Screening Committee No. 302

Title of Agenda: Proposed Layout Plans for Public & Semi Public Facilities pocket at Sector-27 (FC-9) &Sector-28 (FC-3, FC-4& FC-5) Rohini PH-17

File No.Dir.(Plg.)R/4001/Ph-IV/Pt./2005.

Approved Minutes of the 302nd screening Committee meeting held on 17.11.11 in Vikas Sadan.

PROPOSED LAYOUT PLAN FOR PUBLIC & SEMI PUBLIC POCKET [FC-5] AT SECTOR 28 ROHINI PH IV 1 1000 - we noct-2011

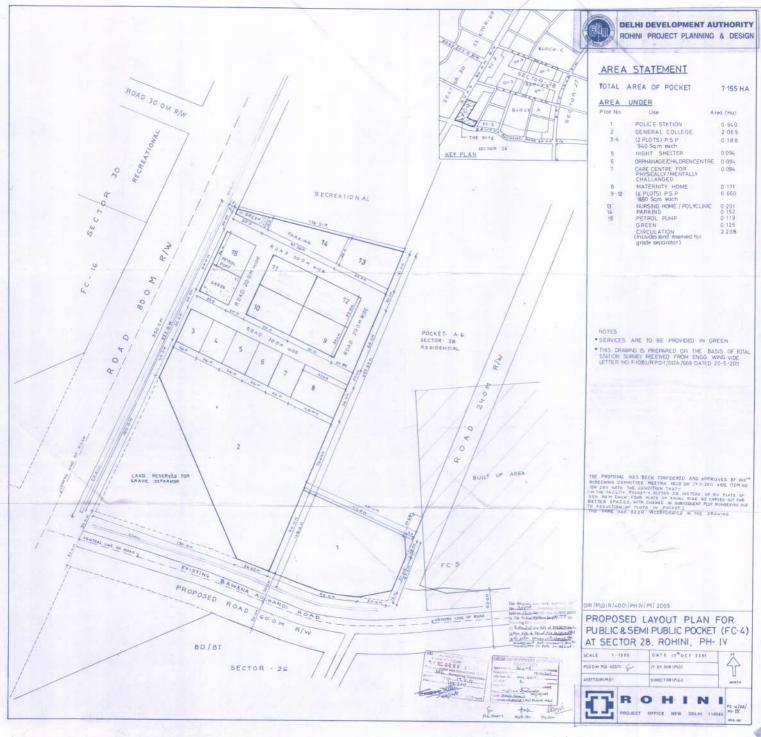
- In the Facility Pocket-9, Sector 27, the width plot no 7(PSP) be increased from 55m 60m and this 5m width be adjusted from Plot no 8(Fire Station).
- In the Facility Pocket-4, Sector 28 instead of six plots of 1100sqm each, four plots of equal size be carved out for better spaces, with change in subsequent plot numbering due to reduction of plots in pocket.
- In the Facility Pocket -5, Sector 28 it was decided that the Recreational Club site be put for Auction to gauge market response.
